Subject: Analysis of Water Availability on Land Proposed for Rezoning from F1 to Crystal Mountain Retreat Centre

Analysis of Groundwater Availability from
Hy-Geo Consulting Reports (2015 & 2021 & 2022) on Crystal Mountain Society land on Galiano

By Tom Mommsen, 10 April, 2022

Figure 1:
Reanalysis of pump test data (WID 23227)
from 210 min time point to 720 min point.
Non-linear regression line fitted to
determine exhaustion point

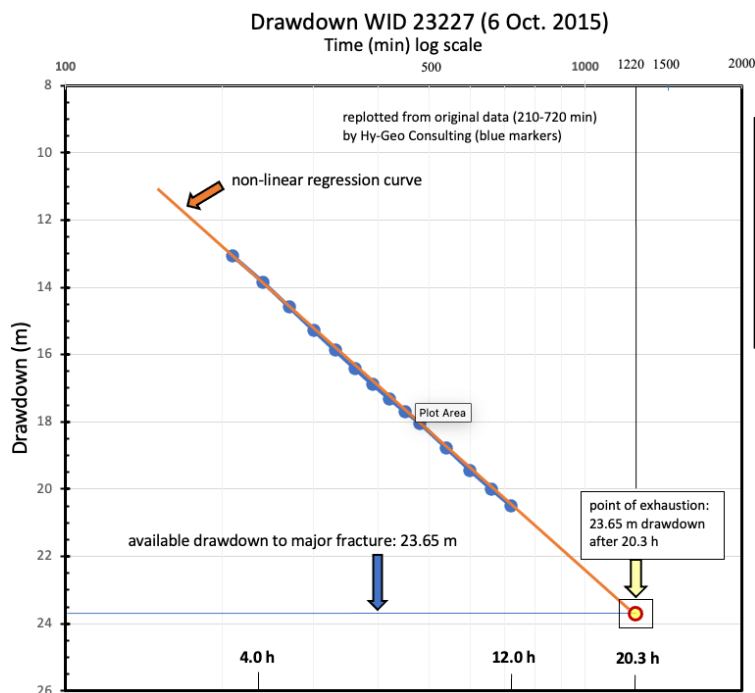
As a re-analysis of the original data shows (Fig. 1), this second pump test, at less than a third of nominal production by the central well, would have also failed - after 20.3 h. This is shorter than the revised and proposed testing protocols for Galiano (LTC 7 March, 2022, page 73, see Appendix I) stipulating 24 h to 72 h pump tests. Surprisingly, HGC did not include comments on the drastic (about 85%) decrease in sustainable water production from this well since its initial drilling 20 years earlier.

Because the central well came within 8 hours of being exhausted by the second test, an extrapolation to a sustainable yield by simply halving the rate of the near-failed test plus incorporating a 70% buffer seems unjustified.

Figure 2: Screenshot from W. Shulba’s presentation to the Galiano LTC (8 October, 2021) showing high vulnerability areas at the North end of Galiano. ▲ indicates CMS property

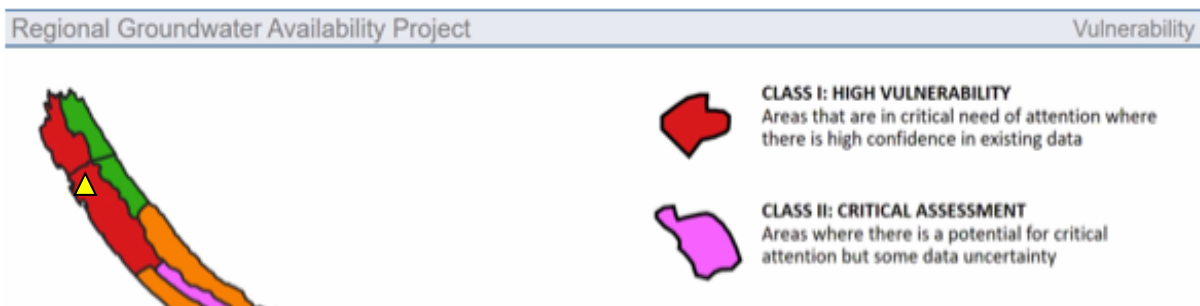
Two additional factors must be considered. First, the west coast of North Galiano already falls into Class 1 (highest) vulnerability classification for groundwater by the Islands Trust (Figure 2).

Figure 3
from: PEI (2011) Saltwater Intrusion and Climate Change. A primer for local and provincial decision makers
www.atlanticadaptation.ca

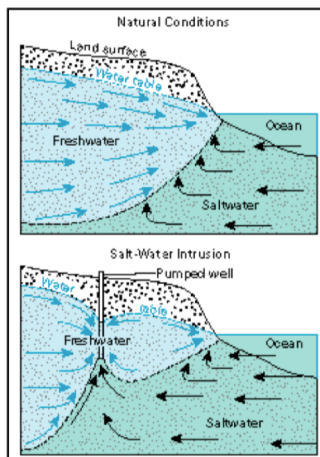
Second, saltwater intrusion is widespread on the NW corner of Galiano and many local wells reach below sea level, including the CMS central well. Oversubscribing any well increases the risk of saltwater intrusion, likely by up-coning (Figure 3), and multiple safeguards need to be put in place to prevent – usually irreversible – saltwater intrusion into any parts of an already vulnerable aquifer. It is surprising that none of these factors are touched upon in any of the HGC submissions on behalf of CMS concerning groundwater.

Figure 5. Drawdown in the central well observed during pumping at 8.07 L/min

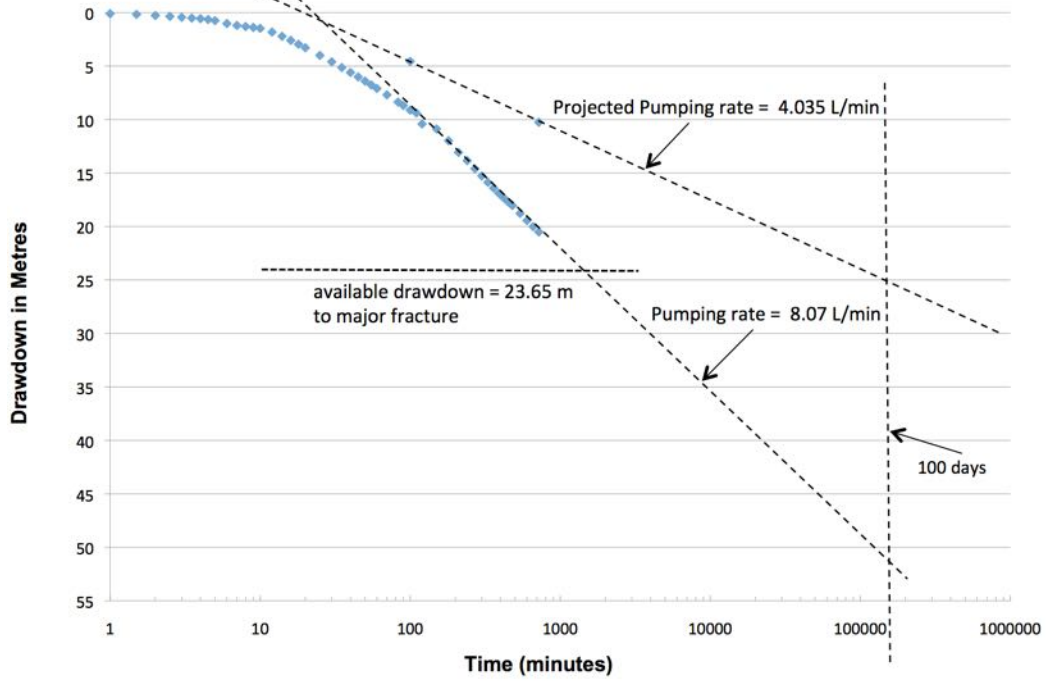
Next day’s pump test (Test 2) at 8.07 L/min (30.5% of nominal production) had exhausted 86.7% of the available drawdown by the end of the test (12 h) (see Attachment II-1 and II-2 - HGC Fig. 5; also HGC Appendix B, Fig 1). Another red flag should have gone up, since such a drastic drop in production is highly unusual, as well, it does not seem to be a good idea to over-pump any well close to maximum drawdown, especially considering its proximity to areas suffering from saltwater intrusion.

The regression line in HGC Fig. 5 (Attachment II-1) indicates that the well would have been exhausted within 20-22 hours even at the lower pumping rate, confirming a compromised well and/or aquifer. Since HGC Fig. 5 etc. (Attachment II - 1) is a semi-log plot, and HGC did not supply the equation for the linear (semi-log) portion of the drawdown curve (sadly also without error terms), I used a visual fit for a regression line (see Figure 1, above). Upon this re-analysis it is obvious that the central well would have definitely failed a standard 24 h pump test at 8.07 L/min. In fact, the lines of maximum drawdown and pumping time intersect at 20.3 hours.

HGC noted (HGC 2015 report, page 15) “As the drawdown showed no evidence of stabilization (my underline) at the pumping rate of 8.07 L/min, it is evident that the well would not be able to sustain this rate for a period of 100 days without recharge”. Surprisingly, no further comment on well or aquifer health had been added.
